**Bid Package 1 | Addendum No. 5**  
**for**  
**Construction of**  
**St. Croix County Health Center Additions and Renovation**  
Project No. 146038

Date: 7/7/2015

**DRAWINGS**

UTILITY PLAN

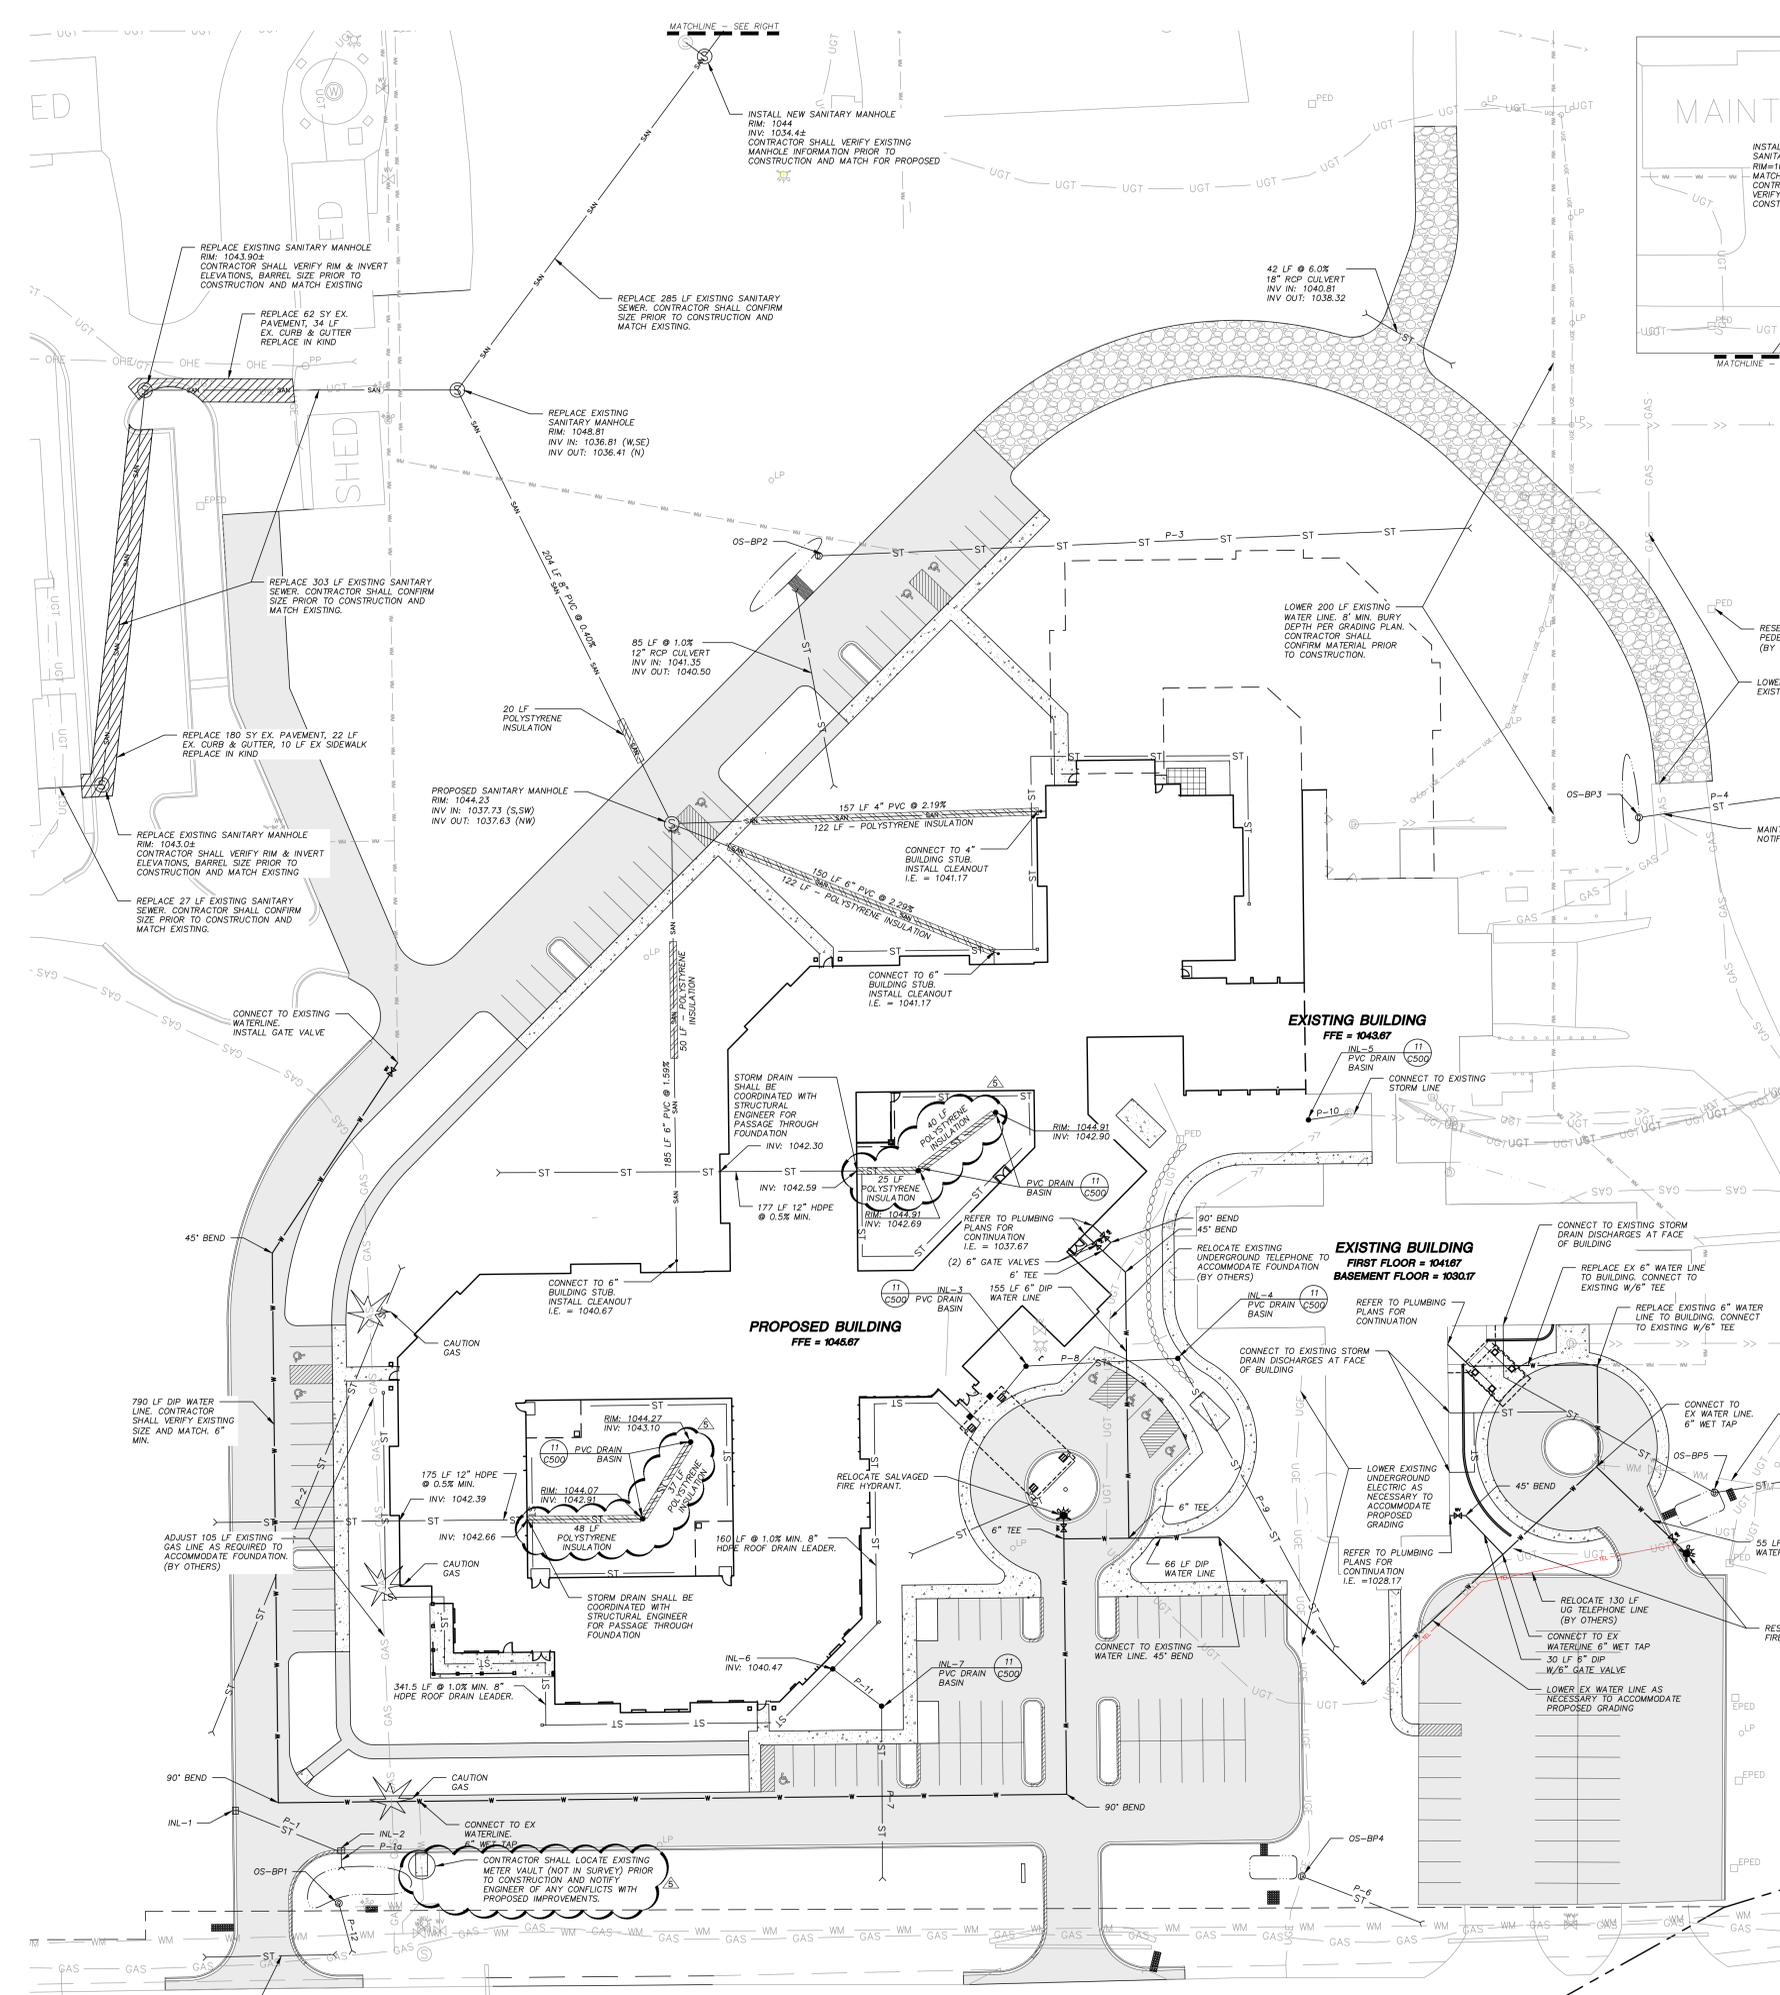
- Polystyrene insulation has been added to courtyard storm drains to address freezing concerns.
- Concrete access for existing meter vault has been added.
- Note #34 requiring that existing water main to be reinstalled shall be pressure tested has been added.

**L100**

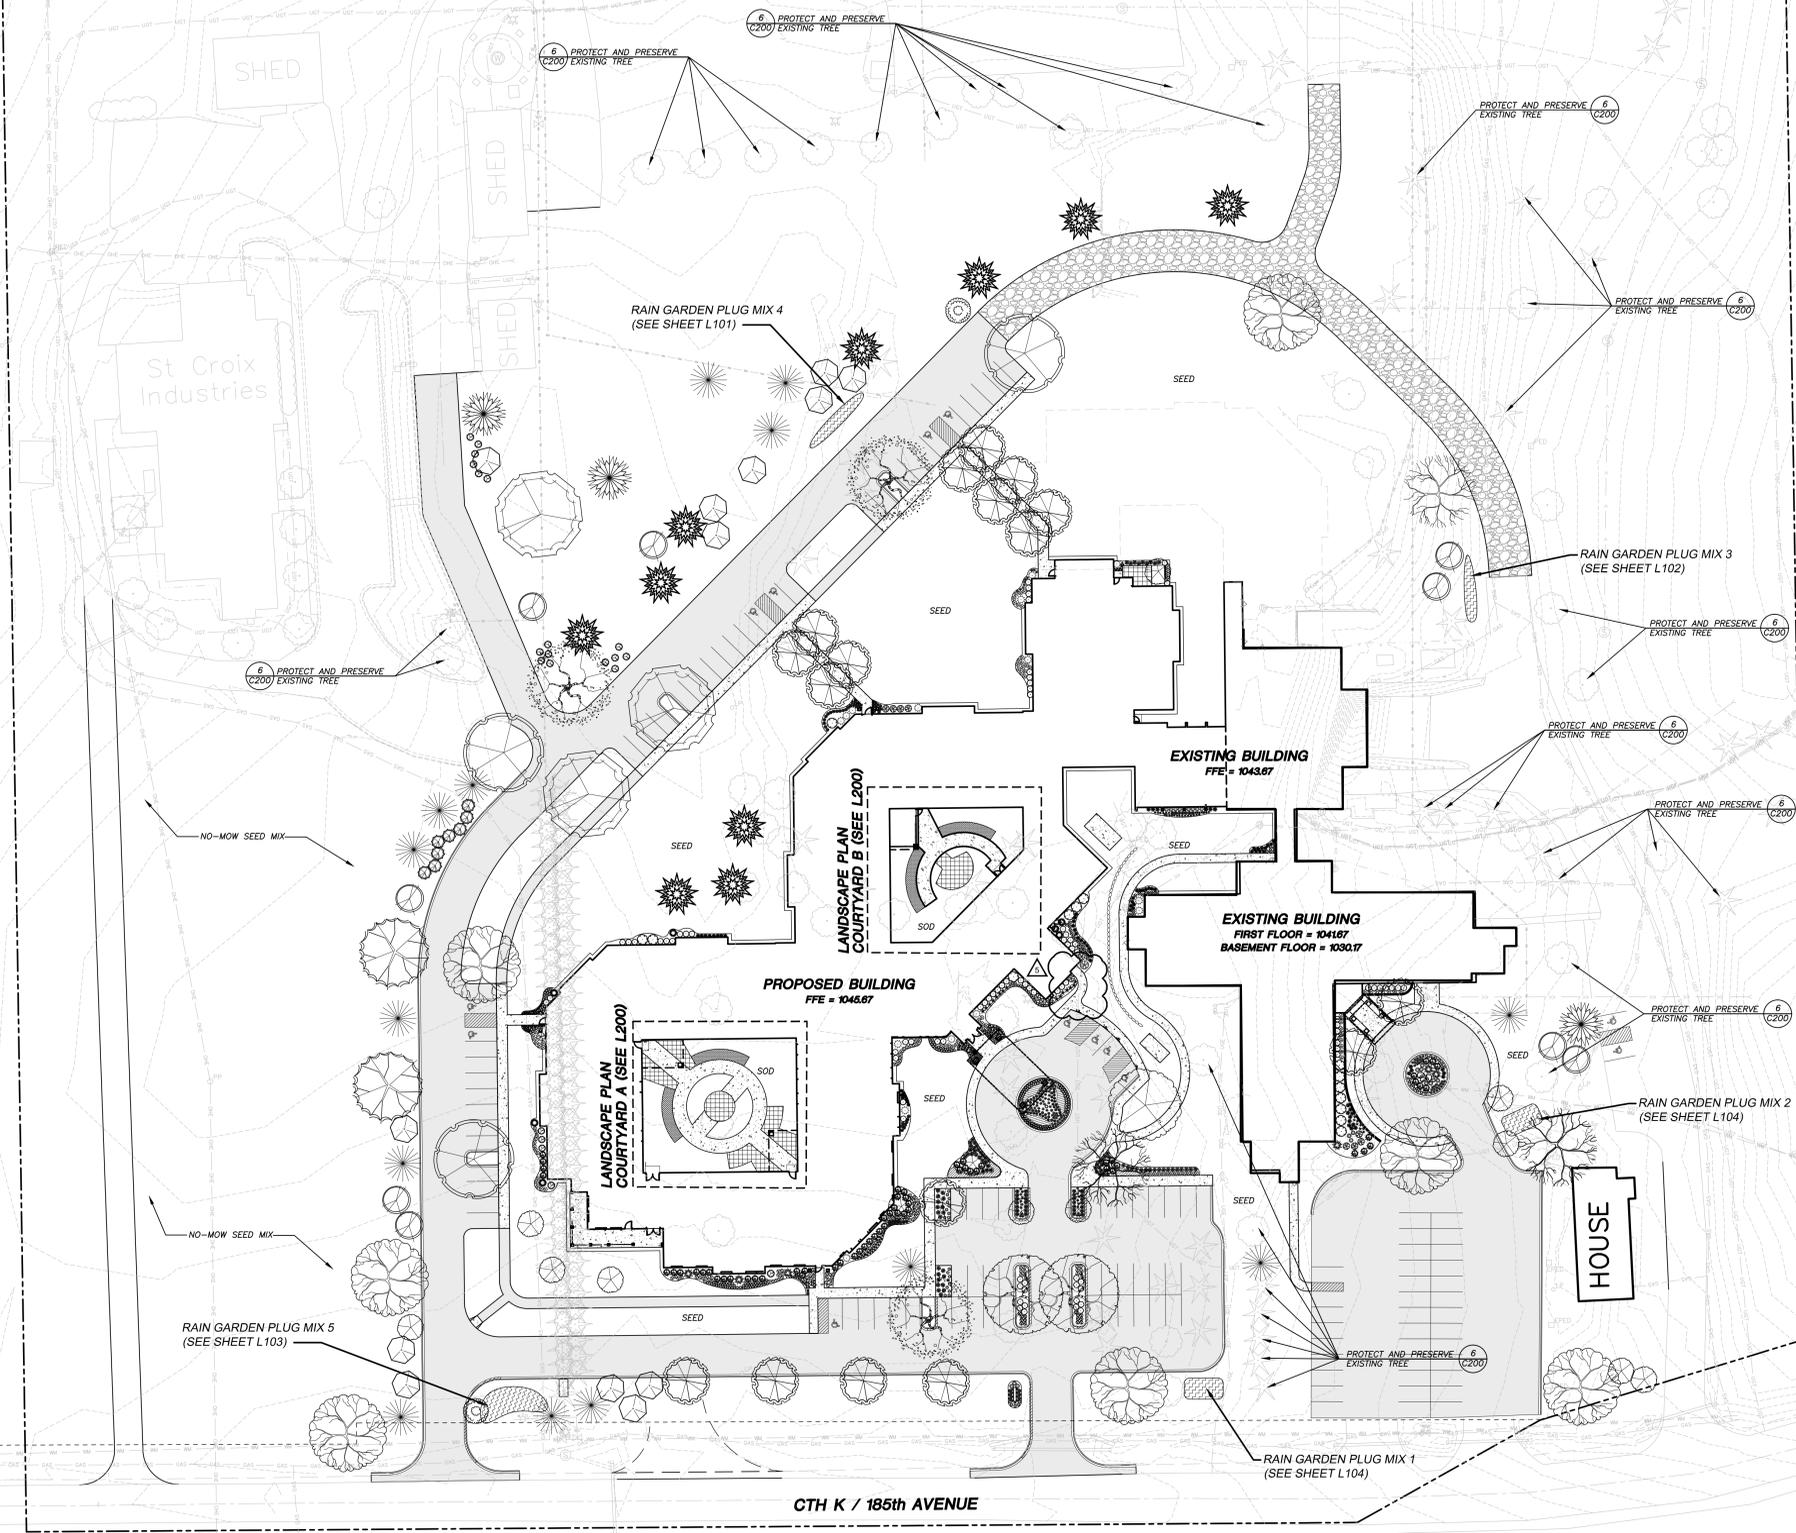
- Addition of path connecting ADA sidewalk to Therapy Pool, Alternate #1.
